Re: Docket No. 70-925; License No. SNM-928  
Response to February 28, 2019 Request for Supplemental Information

Solely as Trustee of the Cimarron Environmental Response Trust (the CERT), Environmental Properties Management, Inc. (EPM) provides responses to Nuclear Regulatory Commission (NRC) requests for supplemental information in your letter dated February 28, 2019. It is our understanding that this additional information is needed to enable the NRC to complete a detailed technical review of the Cimarron *Facility Decommissioning Plan – Rev 1* (the DP).

### EPM Responses to 2/28/2019 Request for Supplemental Information

# Figure 8-1 Western Area Secure Storage Facility

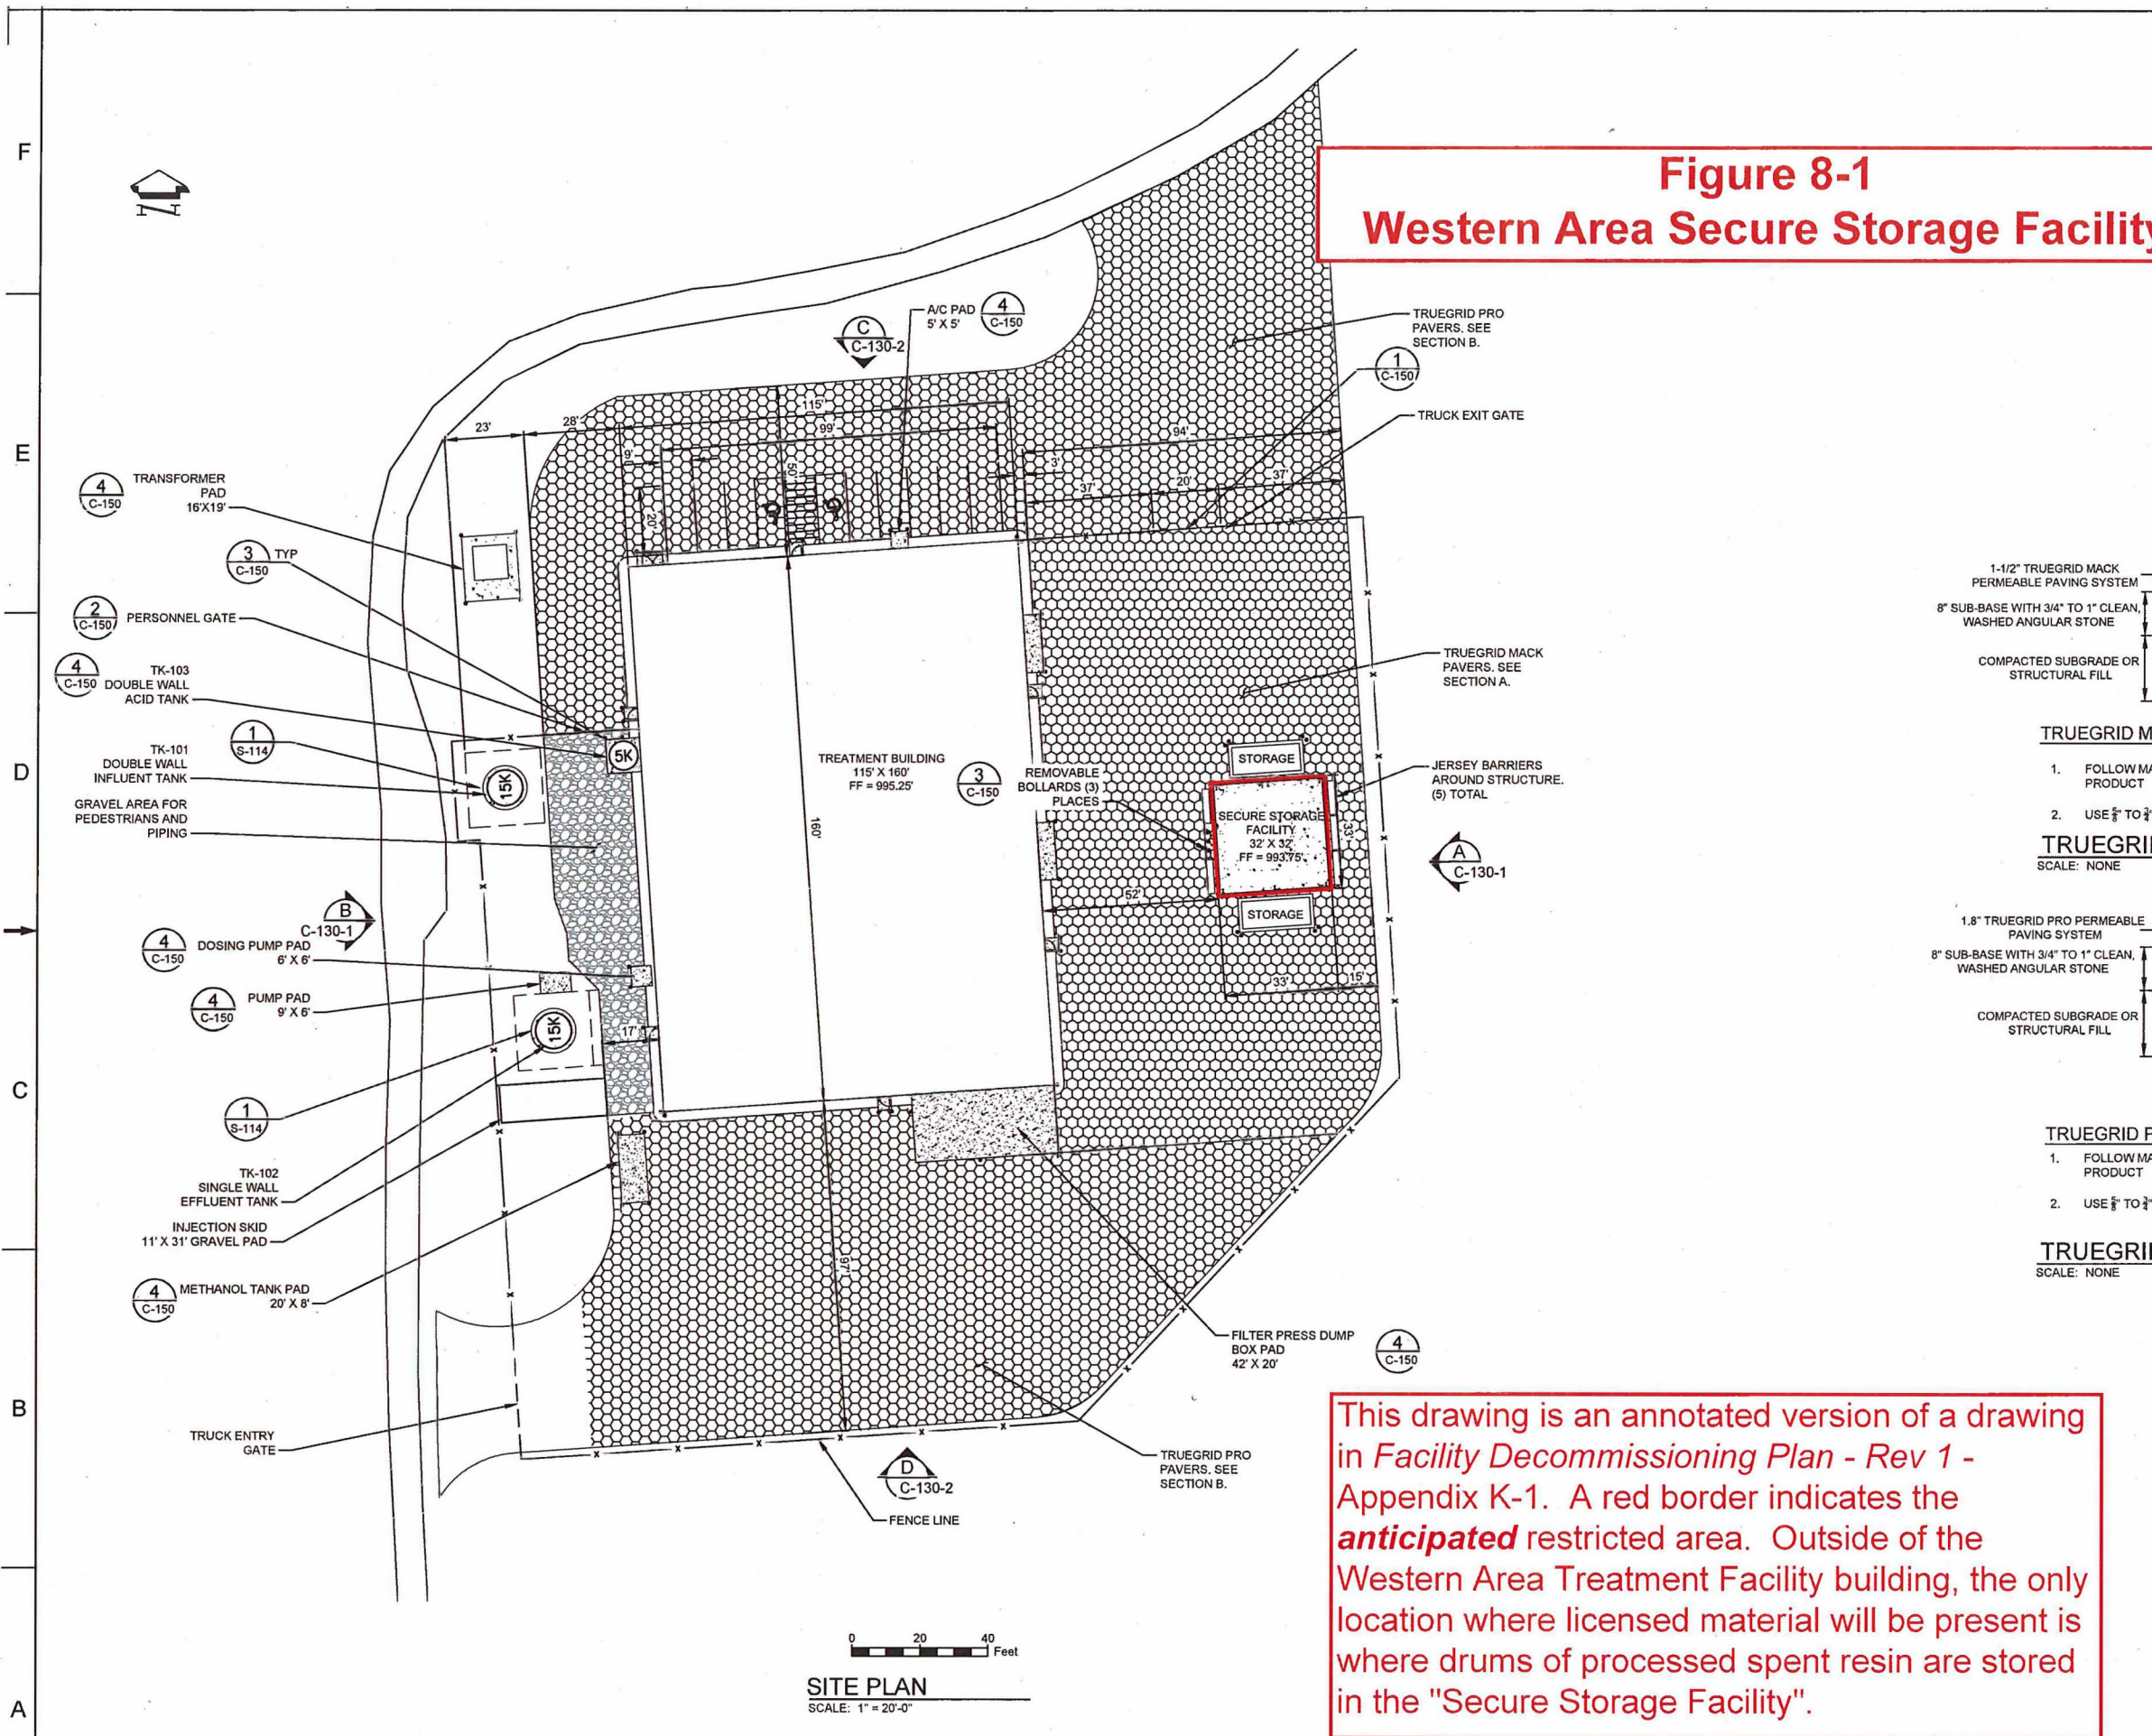
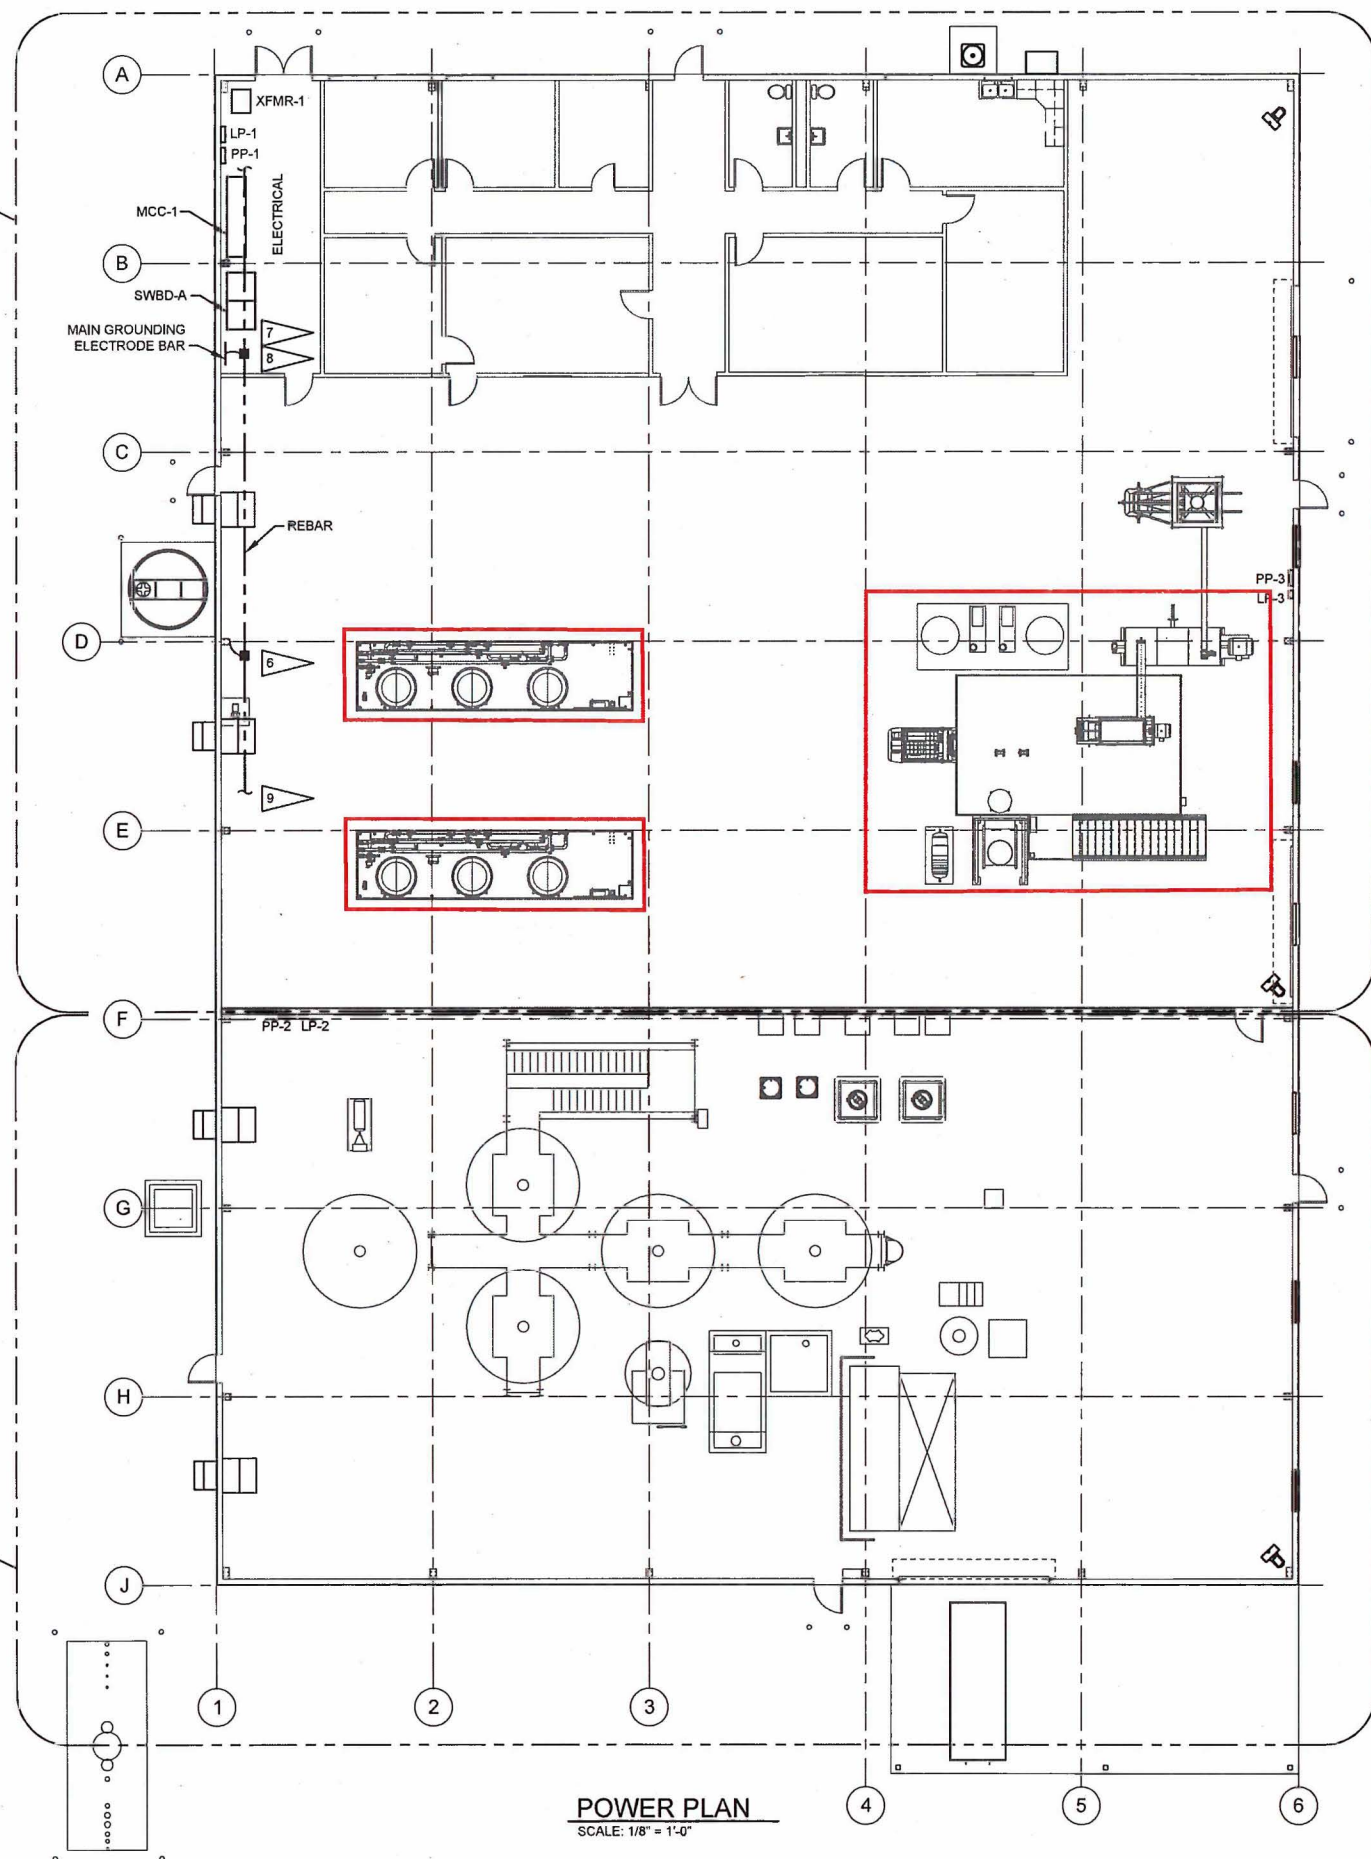
Please provide the following information: 1) A description (e.g., maps) of restricted areas established at site, and 2) the types and frequencies of contamination surveys for restricted and contaminated areas (NUREG-1757, Section 17.3.1.6 suggests a matrix or tabular form).

**EPM Response:** Three figures from Appendix K-2 of the DP have been annotated to show where restricted areas would be located based on the 60% design of the groundwater treatment facilities. These figures will be added to Section 8 of the RPP. Restricted area designations may be modified based on operational experience.

The tentative designation of Restricted Areas during initial groundwater treatment are provided in the following figures:
